# ROUND LAKE AREA SCHOOLS

### WJ Murphy Elementary School 2023 Site Improvements Bid Q&A

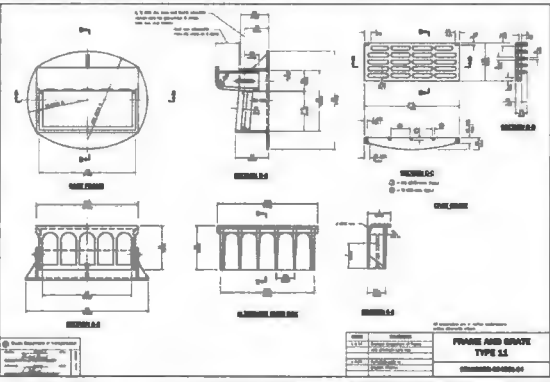
1) Can you provide a detail for the concrete pavement?

**Answer:** Yes. Diagram attached.

**PROPOSED LIGHTING PLAN**  
**WJ MURPHY ELEMENTARY SCHOOL**  
**2023 SITE IMPROVEMENTS**  
**ROUND LAKE PARK, ILLINOIS**

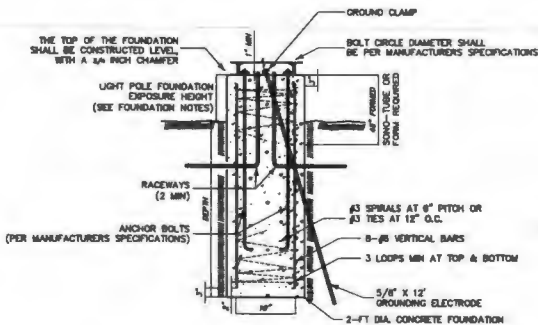
5) Please provide the proposed lighting manufacturer and catalog number as it is not indicated on the lighting schedule. Also, please indicate the location of pole B3 that is to receive the festoon box and also the proposed beacon light location.

**Answer:** Attached are the updated Lighting Sheets. The revised 'Proposed Lighting Schedule' includes the correct luminaire/pole specs and a catalog number. The revised plans also corrected the plan notes, which are now project specific (light pole 'B3' and the beacon lights do not exist in these plans).

<b>SMC</b>		<b>SOIL AND MATERIAL CONSULTANTS, INC.</b>	<b>LOCATION SKETCH</b>
Client:	GEWALT HAMILTON ASSOCIATES, INC.		
Project:	WJ MURPHY ELEMENTARY SCHOOL		
Location:	ROUND LAKE PARK, ILLINOIS		
File No.	26461	Date:	4-8-22
		Scale:	NONE

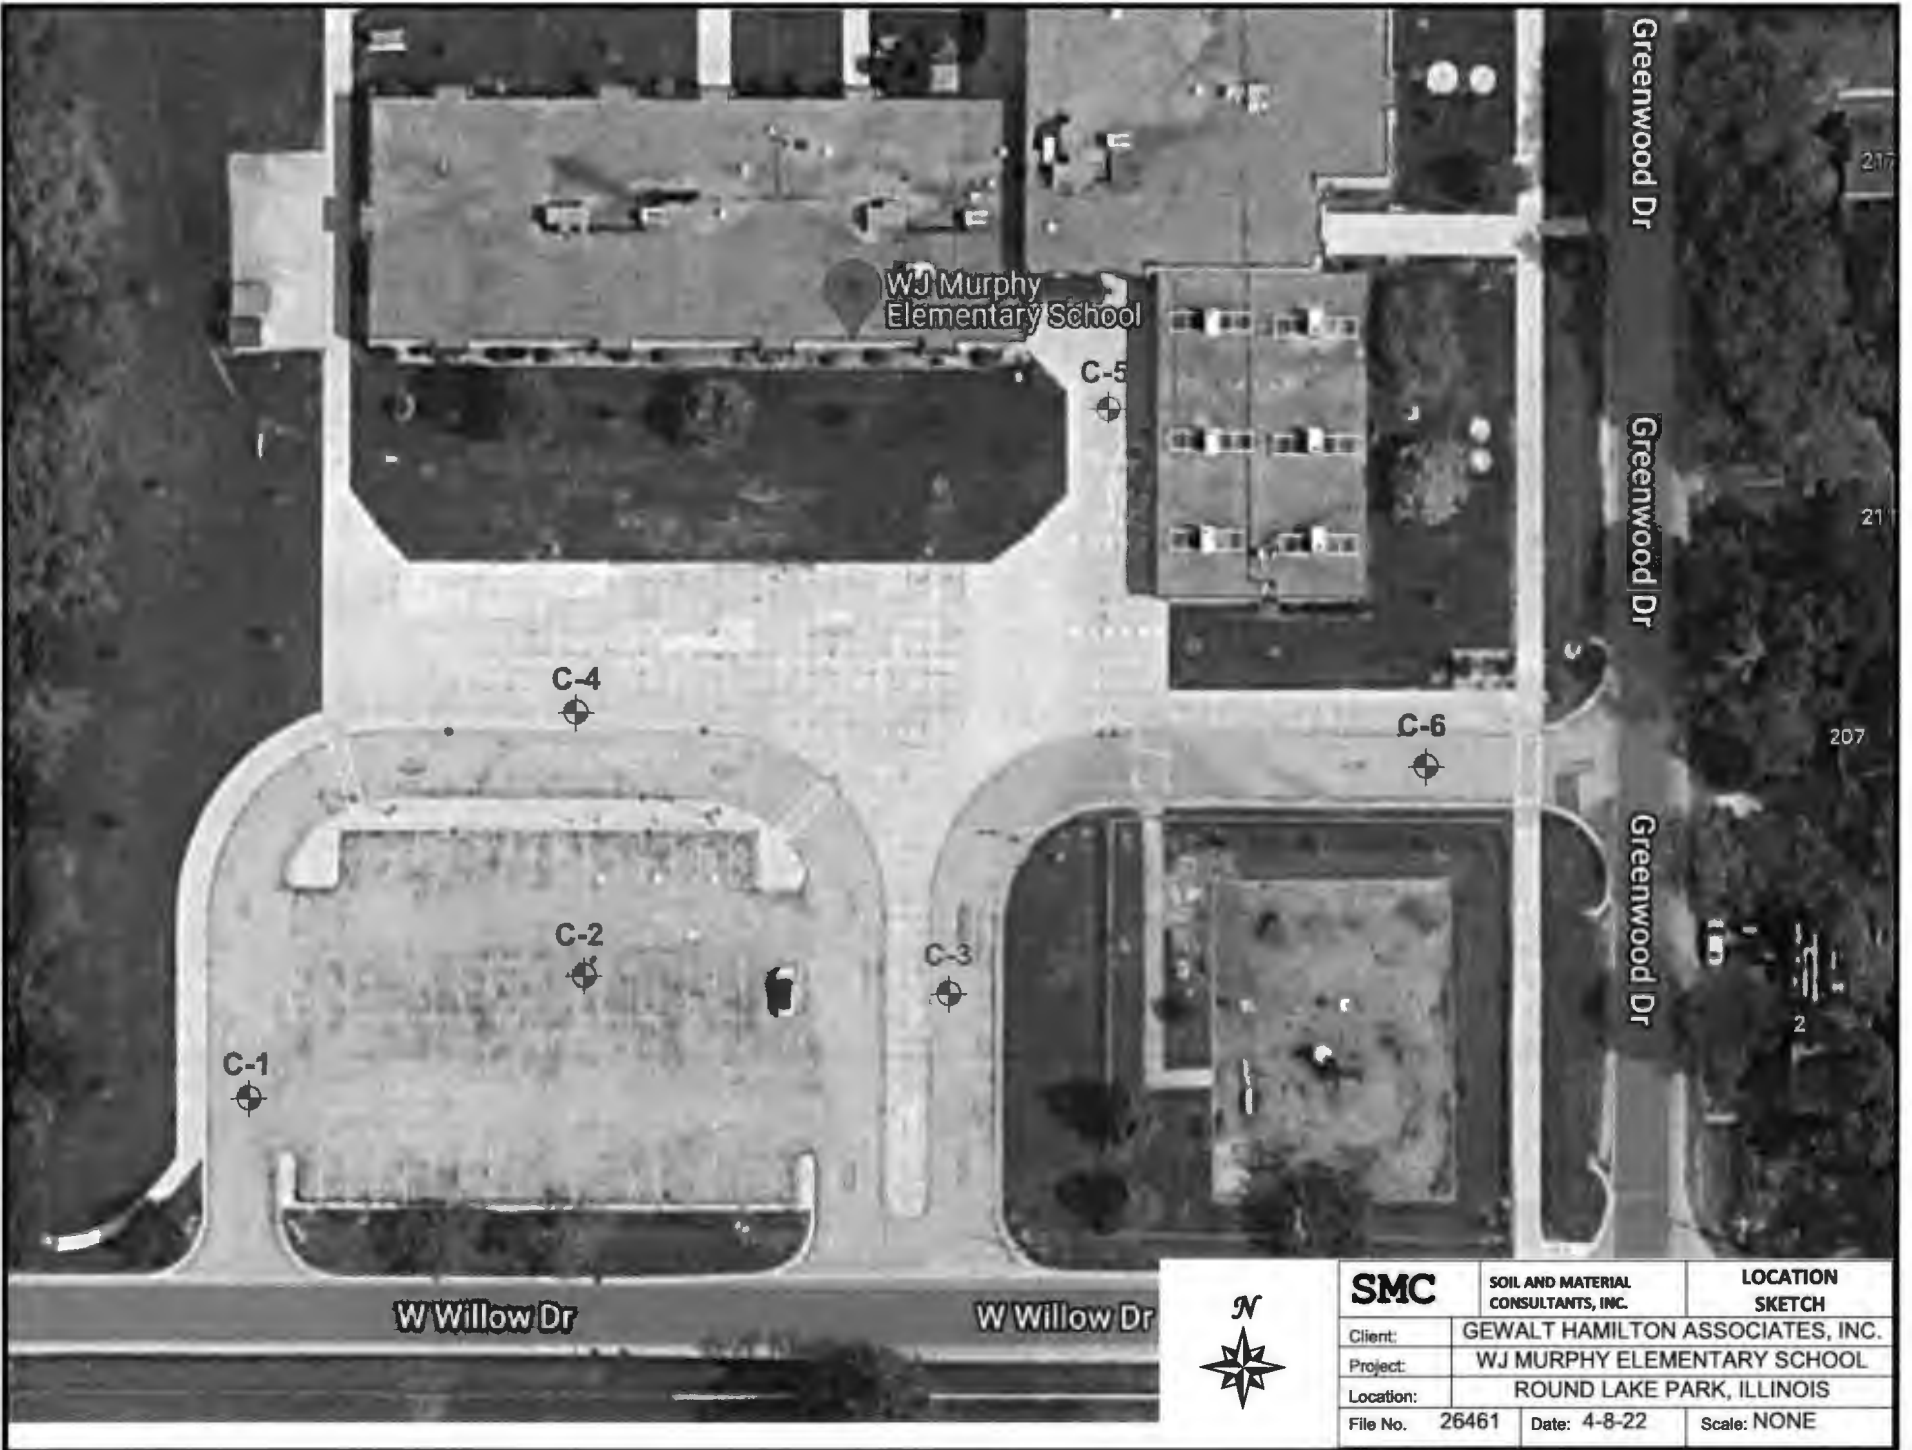
6) Do you have pavement cores that you can share?

**Answer:** Yes. Report is attached.
